Project	IEEE 802.16 Broadband Wireless Access Working Group < http://ieee802.org/16 >	
Title	Corrections for the PKMv2 Key Hierarchy	
Data Submitted	2005-04-27	
Source(s)	Seokheon Cho Sungcheol Chang Chulsik Yoon, ETRI 161, Gajeong-dong, Yuseong-Gu, Daejeon, 305-350, Korea	Voice: +82-42-860-5524 Fax: +82-42-861-1966 chosh@etri.re.kr
Re:	IEEE P802.16e/D7	
Abstract	The existing PKMv2 is somewhat unorganized and insecure security framework. This contribution provides a resolution for secure and uniform key hierarchy in the PKMv2.	
Purpose	Adoption of proposed changes into P802.16e/D7	
Notice	This document has been prepared to assist IEEE 802.16. It is offered as a basis for discussion and is not binding on the contributing individual(s) or organization(s). The material in this document is subject to change in form and content after further study. The contributor(s) reserve(s) the right to add, amend or withdraw material contained herein.

Corrections for the PKMv2 Key Hierarchy

Proposed Changes into IEEE P802.16e/D7

0.1 IEEE P802.16e/D7 Status

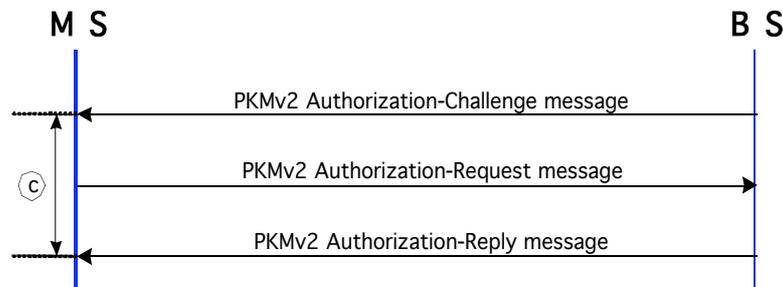
The Key Hierarchy for the PKMv2 is defined. The AK is derived by PAK or/and PMK, SSID, BSID, and so on.

- The AK is derived from PAK or/and PMK which are generated and distributed from the BS and Authenticator, respectively. A Nonce from MS as well as BS is necessary to generate AK so as to make more secure key generation mechanism.

- The input key used for AK generation is the only PMK. The PAK should be also used to generate the AK as not input data but an input key.
- The value of EAP session-id is not changed, even though the new AAA-key is refreshed. That is, even if PMK is updated, the value of PMKID (\Rightarrow hash64(EAP session-id)) and AKID (\Rightarrow hash64(EAP sessionid|PAKID|BSID)) is not also changed. Therefore, AKID is unsuitable as the identifier or sequence number needed to distinguish new AK from old AK.

- The AK lifetime is computed from the value (\Rightarrow MIN(PAK lifetime, PMK lifetime)). To maintain AK more secure, however, the AK should be frequently refreshed. Different definition of the AK lifetime is necessary.

Figure 131-AK with the only RSA-based only authorization process

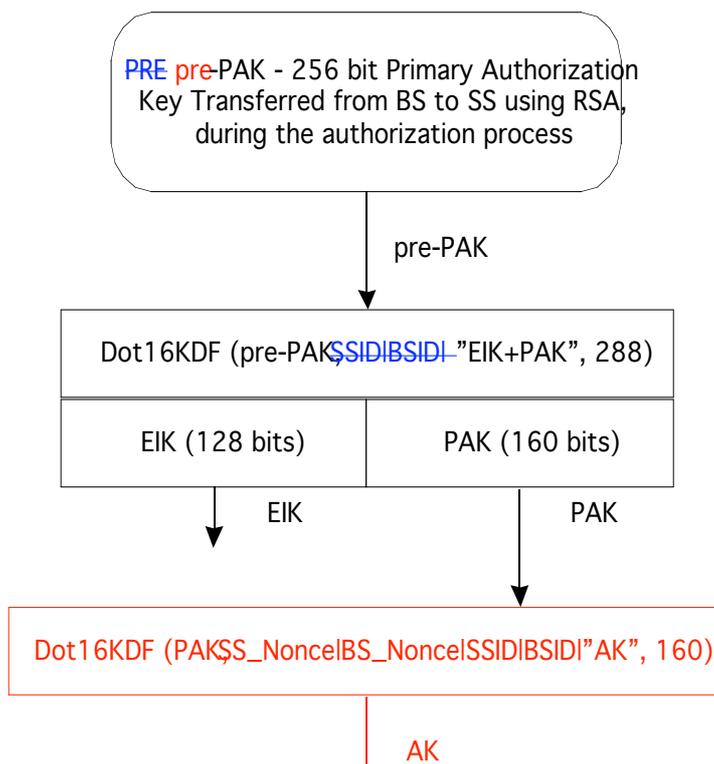
Figure 131 outlines the process to calculate the AK when the RSA-based authorization process has taken place, but where the EAP-based authentication process hasn't taken place, or the EAP method used has not yielded an AAA-key:

Figure 132-AK with RSA and EAP authorization process

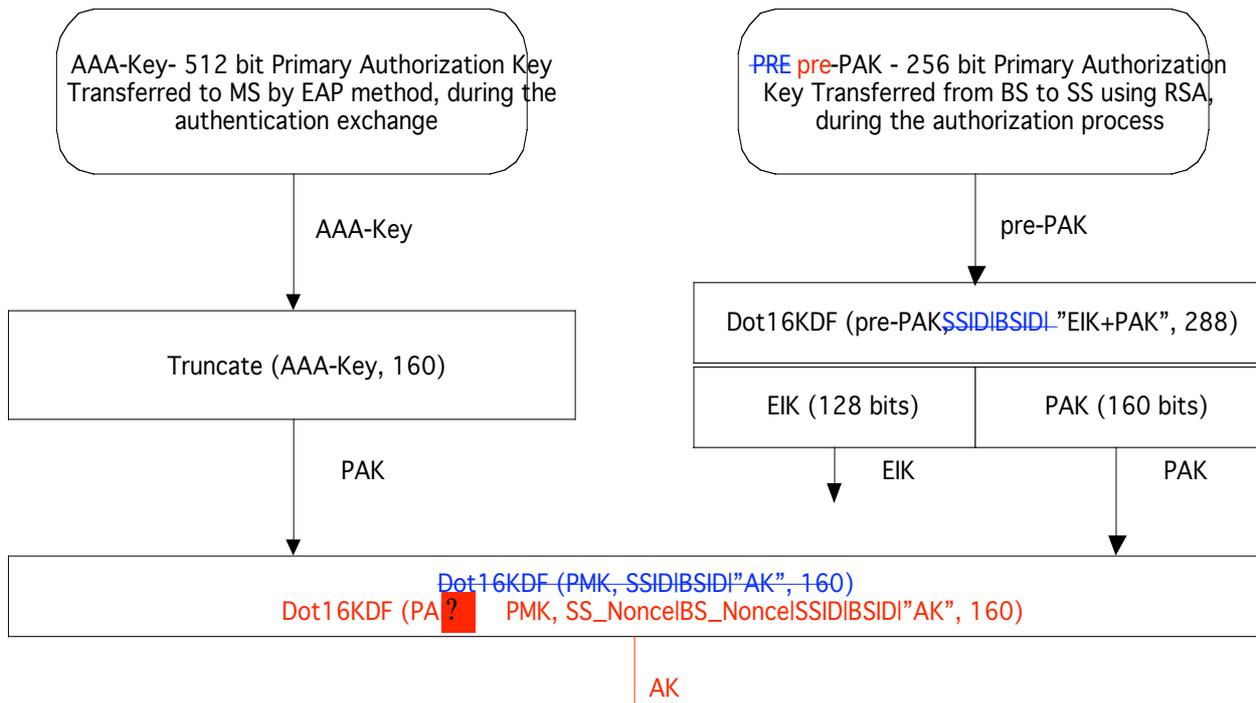
Figure 132 outlines the process to calculate the AK when both the RSA-based authorization exchange has taken place, yielding a PAK and the EAP based authentication exchange has taken place, yielding an AAA-key:

Figure 133-AK with the only EAP-based authentication authorization process

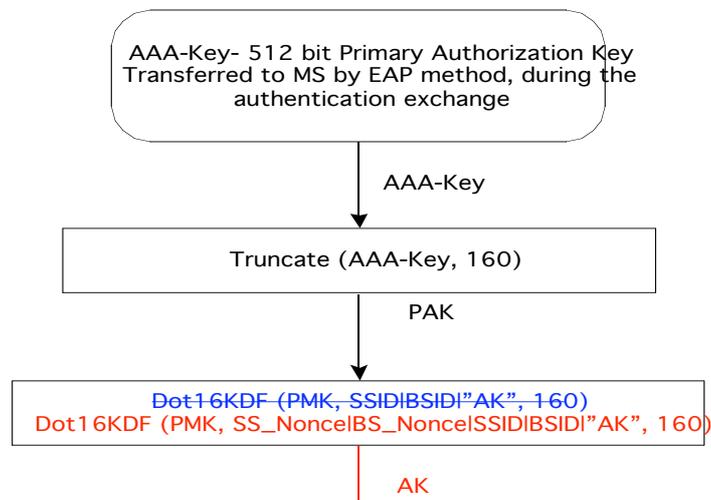
Figure 133 outlines the process to calculate the AK when only the EAP based authentication exchange has taken place, yielding an AAA-key:
